From: [REDACTED]
To: [REDACTED]
CC: [REDACTED]
Sent: 2/24/2021 9:28:40 AM
Subject: RE: O8W-PM 35217268, 35224712, 35224713 - Bucks Creek 1101 Phase 1,2&3 - Pre-Engineering Meeting

Bucks Creek 1101- PM# 35217268 Overview Map

PM 35217268 (Phase 1)

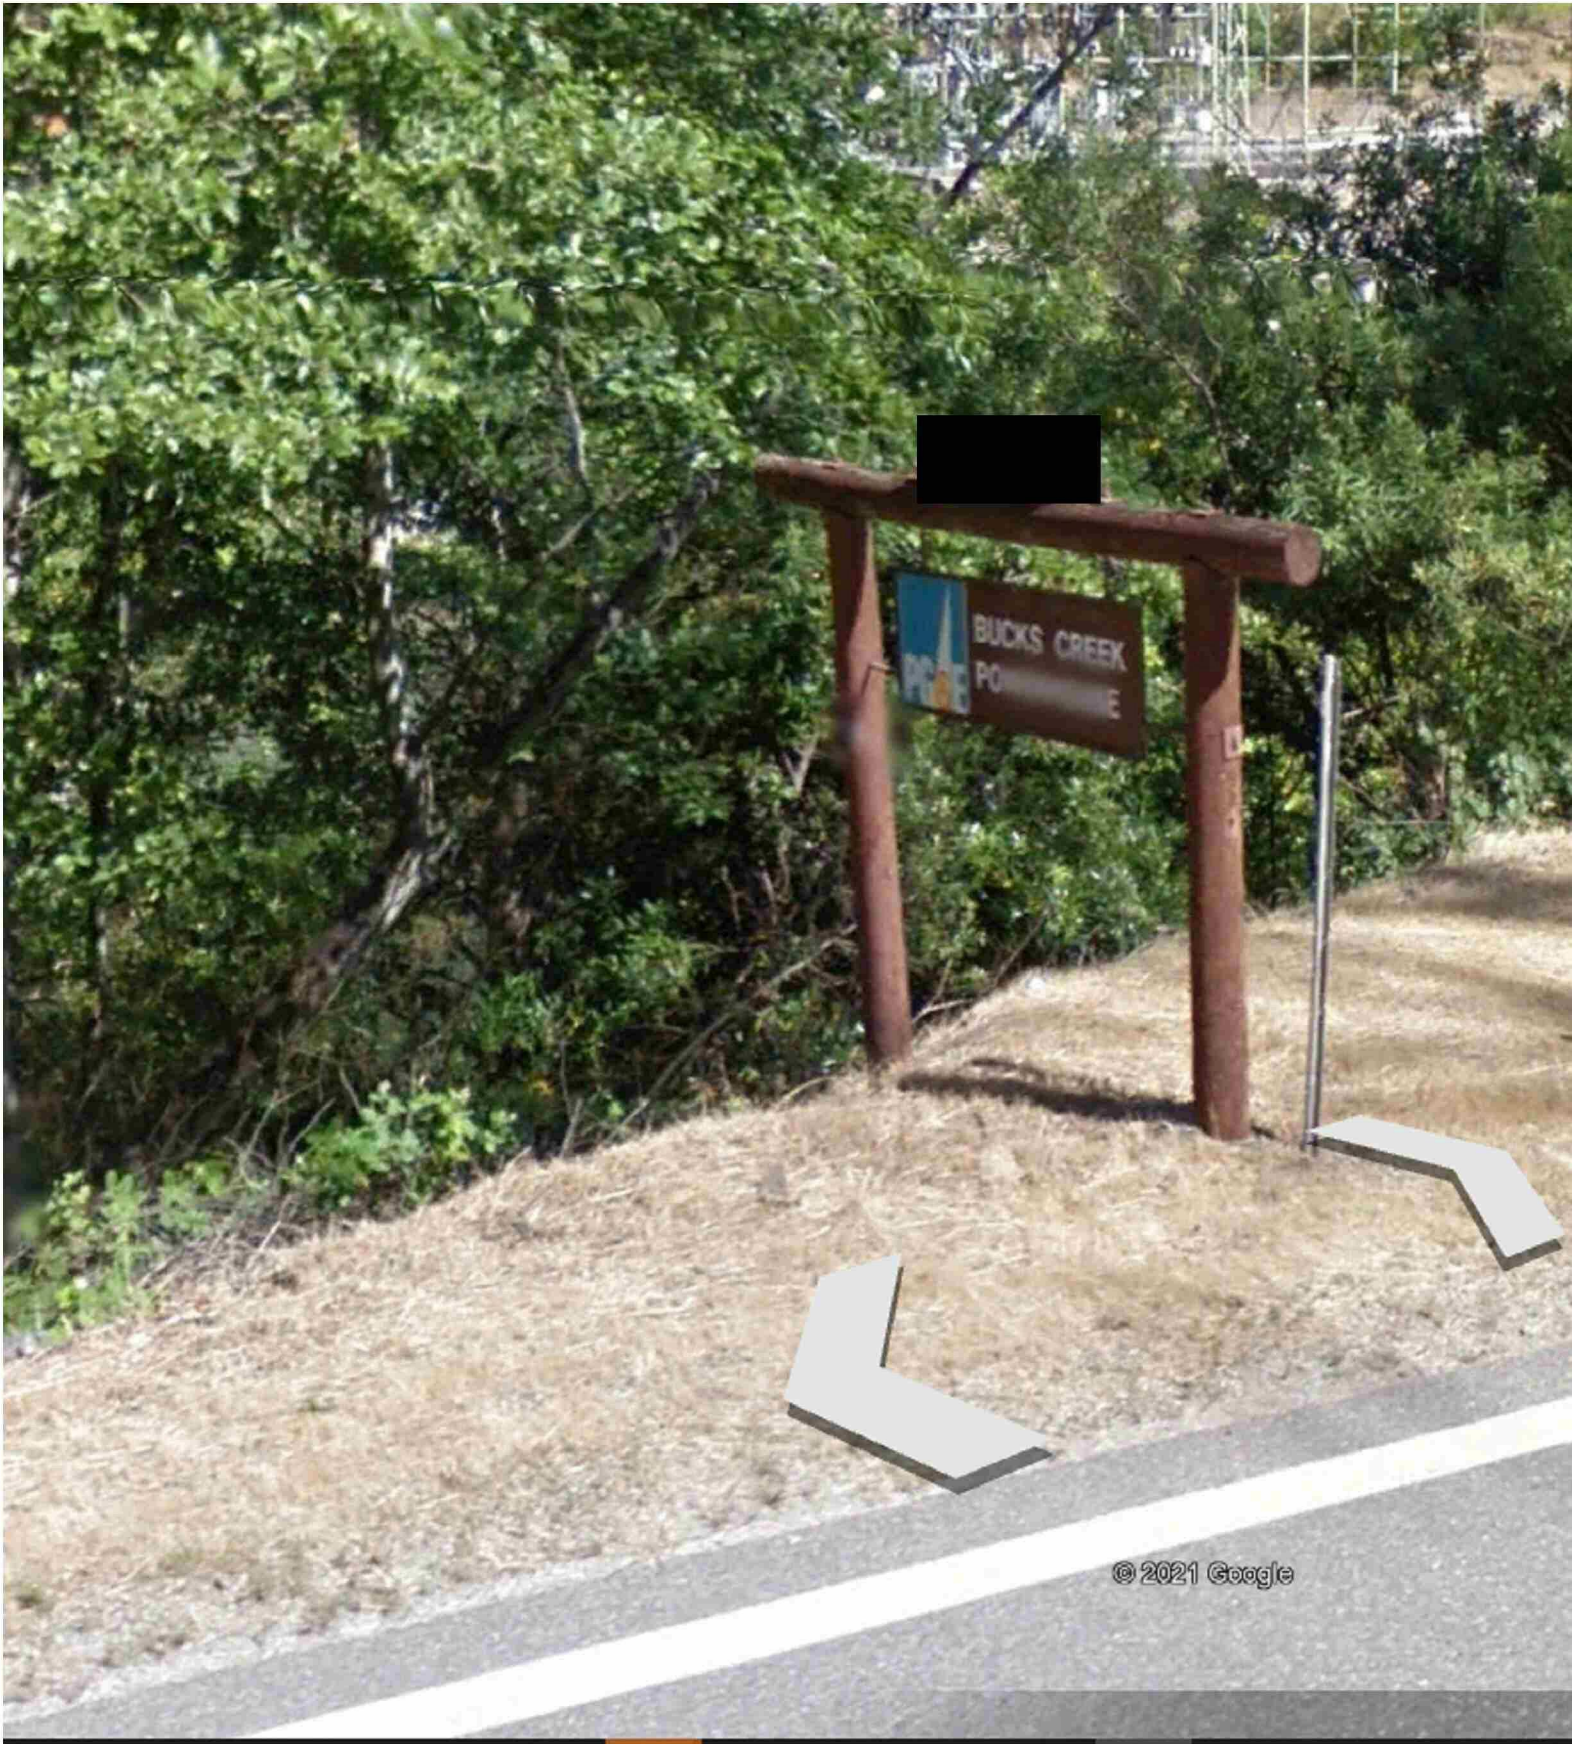
Attached are the 'base-map' limits in a kmz. file. As you will see, we need our base-map to go about ~100' into the tunnel at the south end (see pedestal in picture below.....please begin about ~50 beyond this point which is about ~100' beyond the Cresta Dam).

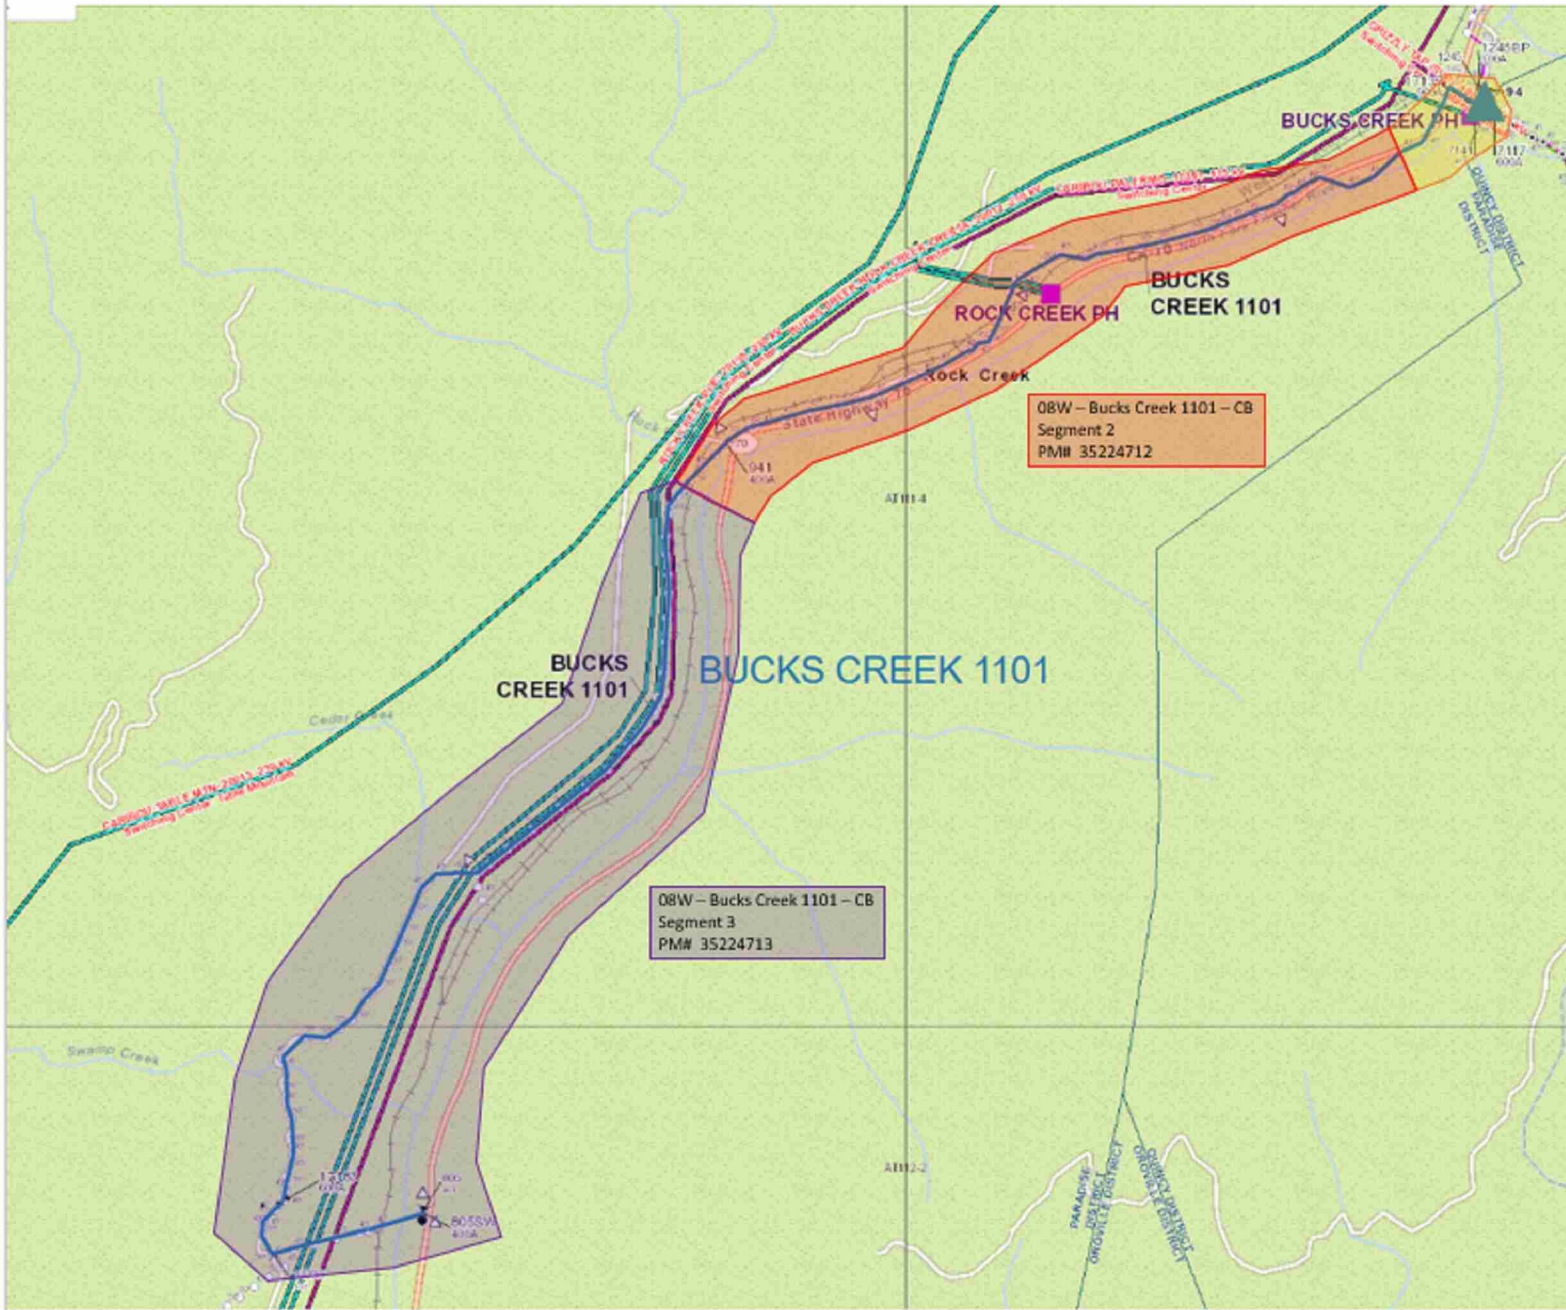
For Bucks Creek there is quite a bit of work surrounding Hwy 70 and we will need a Land Department Base Maps prepared for all 3 Orders. This will delay the EOD dates until these can be developed and provided to the Vendor... We will also need answers to the questions outlined by [REDACTED] below...
